## PLANNING COMMISSION MEETING

Project Name: Culver's  
 Description: Preliminary site plan approval  
 Date on Agenda this packet pertains to: May 2, 2024

**RE: Culver's- Preliminary Site Plan Review – 2<sup>nd</sup> Review**

RE: Culver’s  
Preliminary Site Plan – Review #2

SITE LANDSCAPE PLAN

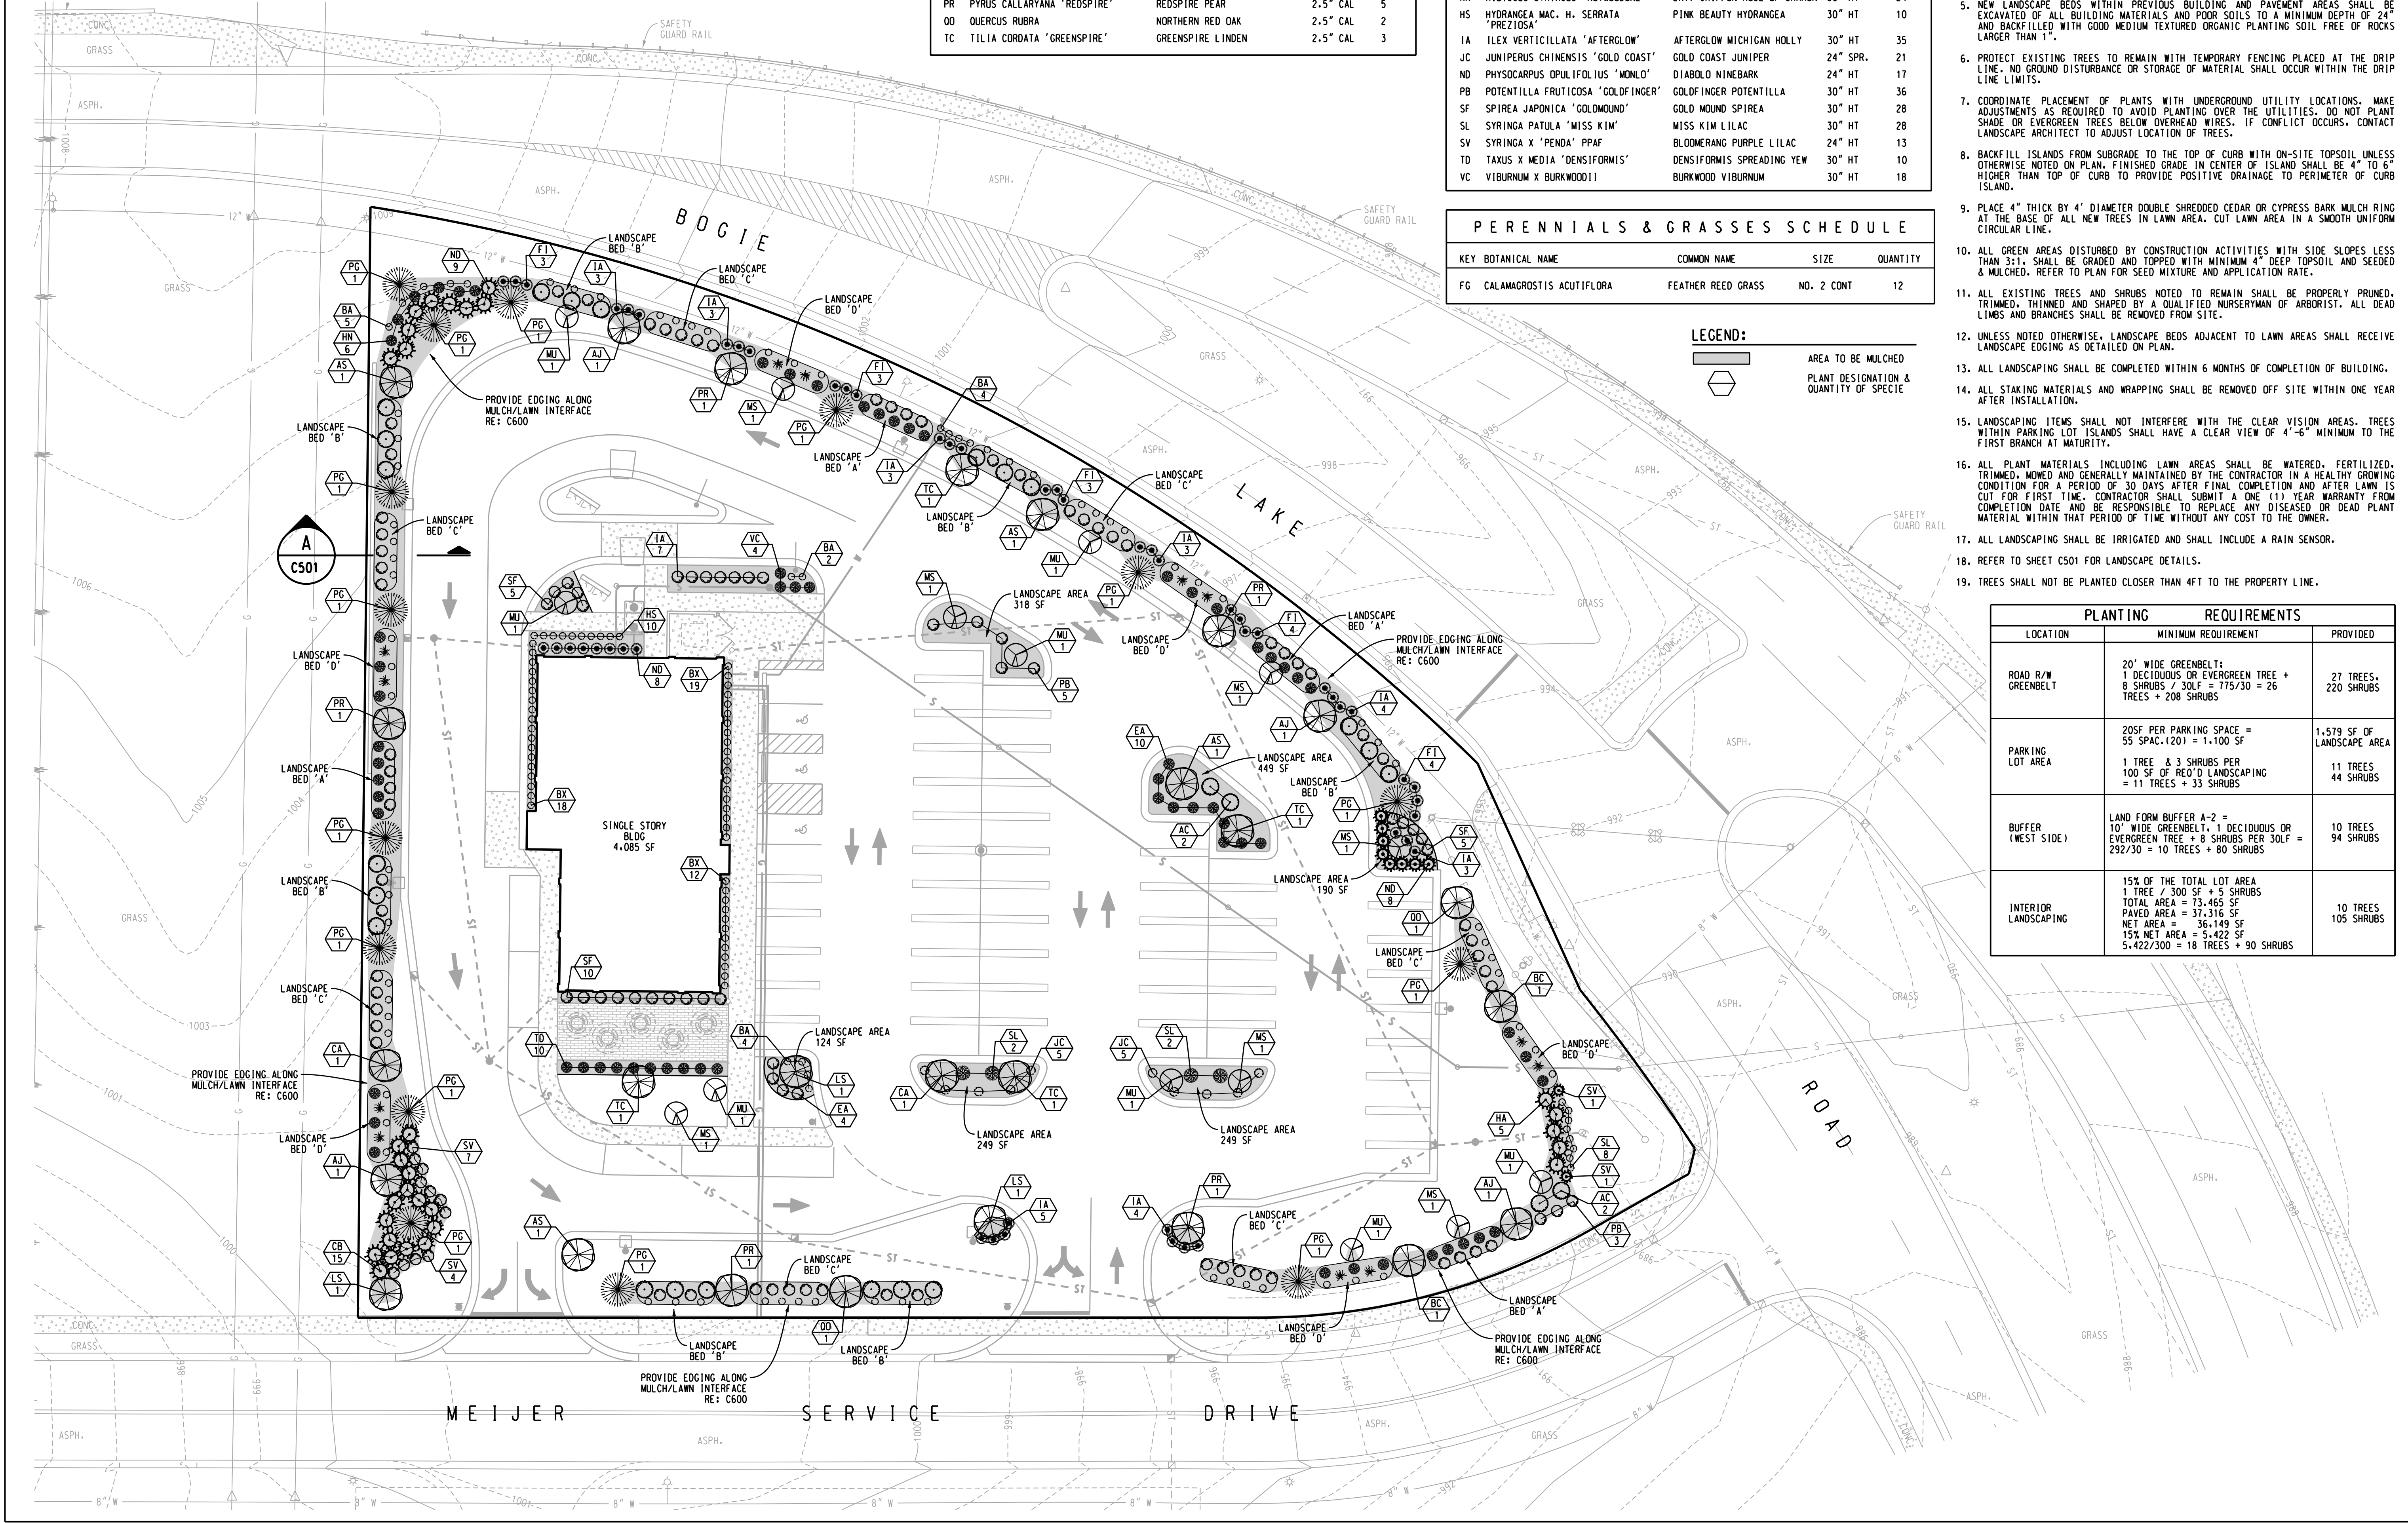
- x) *Sheet C500- There are several locations where proposed trees are shown too close to proposed sanitary sewer, water service, and storm sewer. Please provide a minimum of 10' horizontal separation between trees and these utilities. We have attached a red lined copy of this plan sheet for exact locations. Comment addressed. Landscape plan has now been revised. All proposed trees are now shown a minimum of 10' away from proposed sanitary sewer, water service, and storm sewer.*

- Note areas for snow storage are depicted on Sheet C200.
- Trees shall not be planted closer than four feet to a property line. **Add note to landscape plan at final site plan.** (Comment addressed. Note 19 has been added to Sheet C500).

- **The Planting Requirements Table on Sheet C500 shall be revised. The minimum requirement listed for the west side buffer is incorrect. A greenbelt 10 feet in width planted with 1 large deciduous or evergreen tree and 8 shrubs for every 30 linear feet is required. Revise accordingly. (Comment partially addressed. While the greenbelt requirement has been added, the following wording still needs to be removed: “Land Form Buffer A-2 =”).**

1 EAST (RIGHT SIDE) ELEVATION (AREA OF E.I.F.S. = 11%)  
 A-3 SCALE: 1/8" = 1'-0"

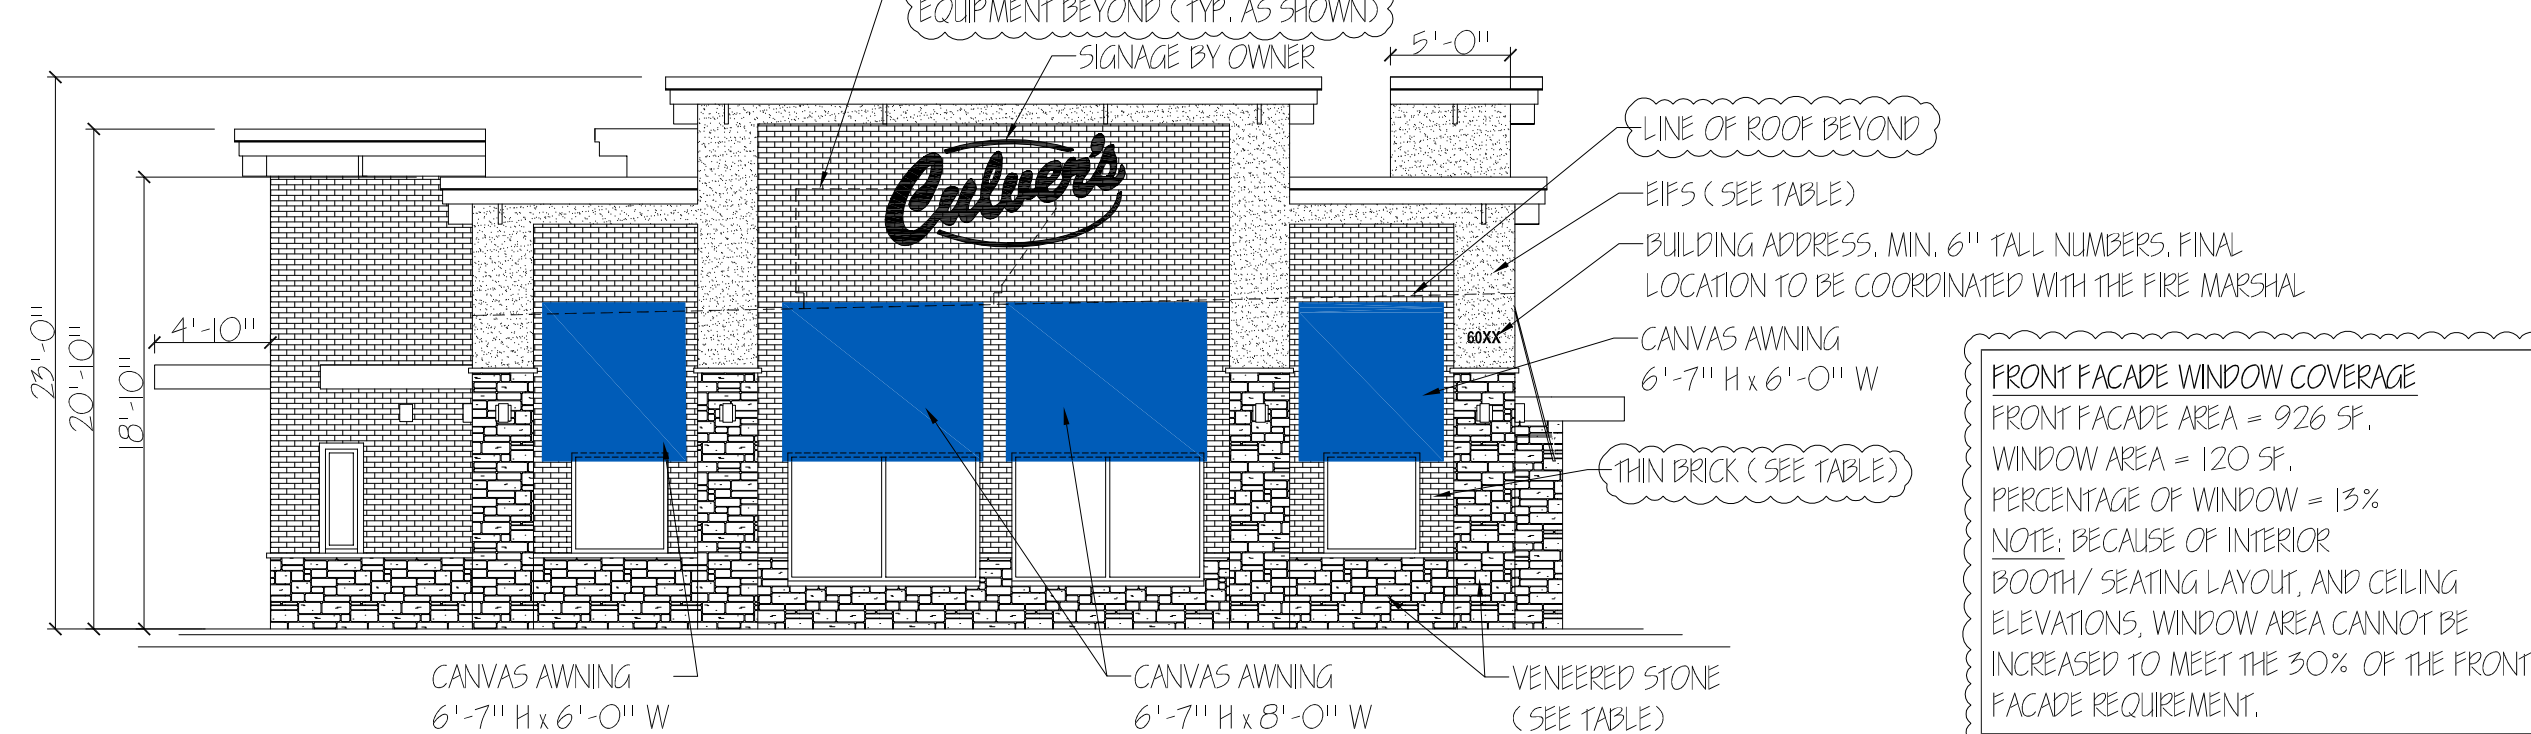
Commissioner Carlock asked staff about window coverage. Staff Planner Quagliata said the zoning ordinance required 30% window coverage on the east elevation of the building, and the applicant only proposed 9.27% coverage on their plan. The applicant would need to seek a variance for the reduction in coverage.

**The Zoning Ordinance states all buildings should have windows at eye level covering at least 30 percent of the front facade. The exterior elevations should be revised to provide the required windows, and a window coverage calculation shall be provided on the building elevations at final site plan.** (Comment outstanding. A waiver is required because 30% window coverage on front facades is not provided. The east and north elevations are also considered front facades (due to fronting on roads) and shall be labeled as such on Sheet A-3, with window coverage calculations provided for those facades. Also, revise requested waiver seven on Sheet C000 to reflect the three affected facades).
